**Re: Port Haney Multi-Use Pathway (MUP)**

HUB Cycling's Maple Ridge/Pitt Meadows Local Committee appreciates the opportunity to provide feedback on this exciting project.

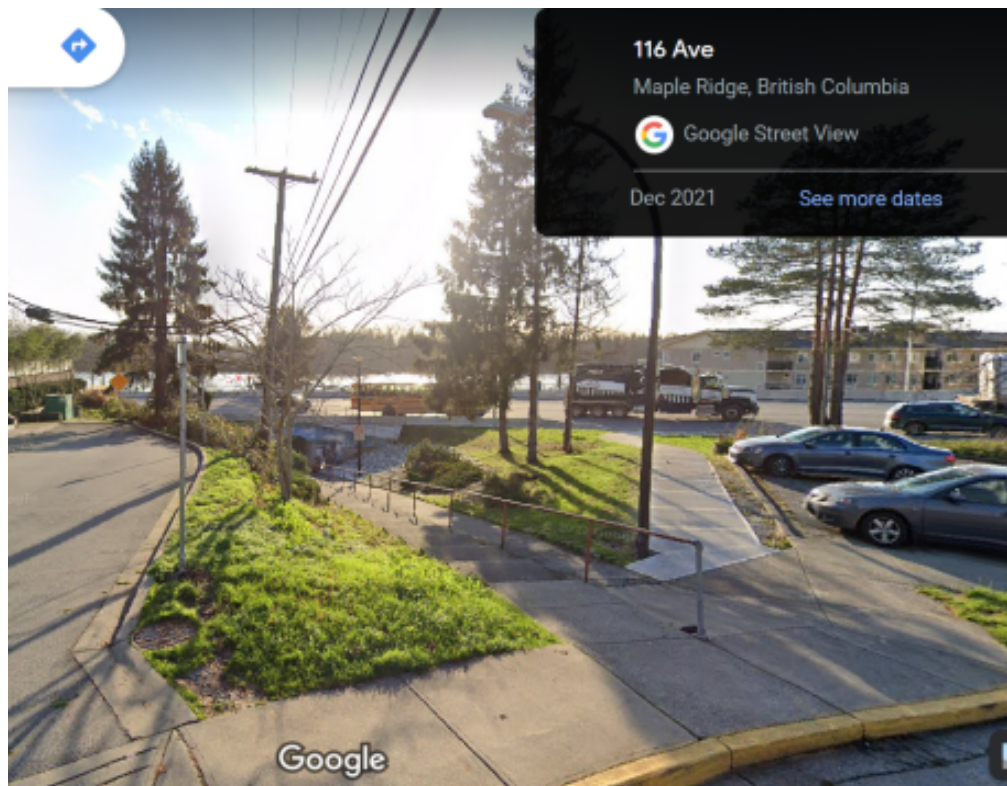
The present active transportation connection from the Kanaka Way MUP north of Lougheed to the parking lot at the Kanaka Creek Riverfront Park involves crossing a total of 15 lanes of traffic and activating 4 crossing lights at the Lougheed/Kanaka Way/Haney Bypass intersection, which is very cumbersome, inefficient and unpleasant.

Adding a crossing for people walking, rolling and cycling on the south-east side of the intersection would be a big improvement. Such a crossing would leave only 8 car lanes to be crossed, and 2 crossing lights to be activated.

We understand that this is not part of the project and it's under the jurisdiction of the Ministry of Transportation and Infrastructure. We strongly recommend that the municipality should coordinate this project with the Ministry of Transportation and Infrastructure to fill this crucial gap in the active transportation network to facilitate the usage of this connection.
